Service Bulletin

Bulletin No.: 23-NA-030

Subject: Airbag Light On - DTCs B0014 / B0021 SIAB Harness Connector Contacting Seat Back Foam (New Seat Back Foam), Intermittent Service Airbag System Message, DTCs B0014, B0021

Brand:	Model:	Model Year:		Build Date:		Engine:	Transmission:
		from	to	from	to		
Chevrolet	Bolt EV	2022	2023	—	December 16, 2022	All	All
	Bolt EUV

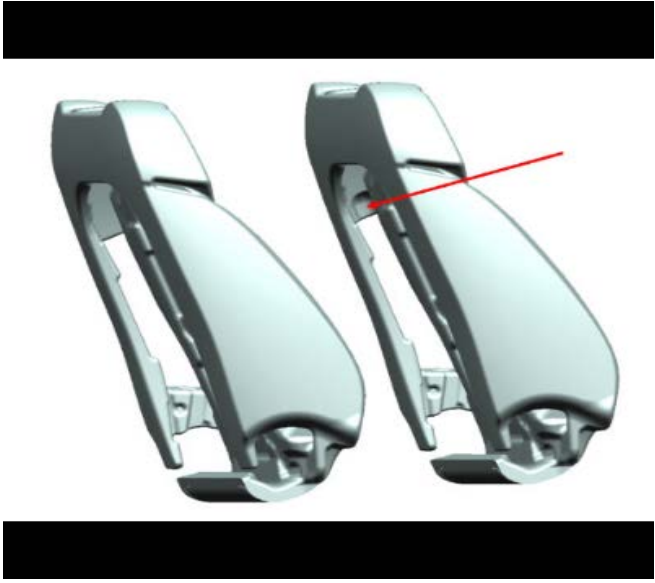
Involved Region or Country	North America, Middle East, Brazil, GM Korea Company
Condition	Some customers may comment on a "Service Restraint System" message displayed in the driver information center (DIC). Some customers may also comment on the Airbag Readiness Light coming on intermittently after start up. Technicians may also find DTC B0014 or B0021 with symptom byte :04 or :0D active or in history.
Cause	The condition may be caused by an interference between the front seat back pad assembly and the side impact airbag wiring harness assembly.
Correction	<div style="text-align: center;">  </div> <p style="text-align: right; font-size: small;">6325181</p> <p>Replace the front seat back pad assembly with a new part number that includes a larger clearance zone for the side impact airbag wiring harness assembly.</p>

If you encounter a vehicle with the above concern, replace the front seat back pad. Refer to *Front Seat Back Cover and Pad Replacement* in SI.
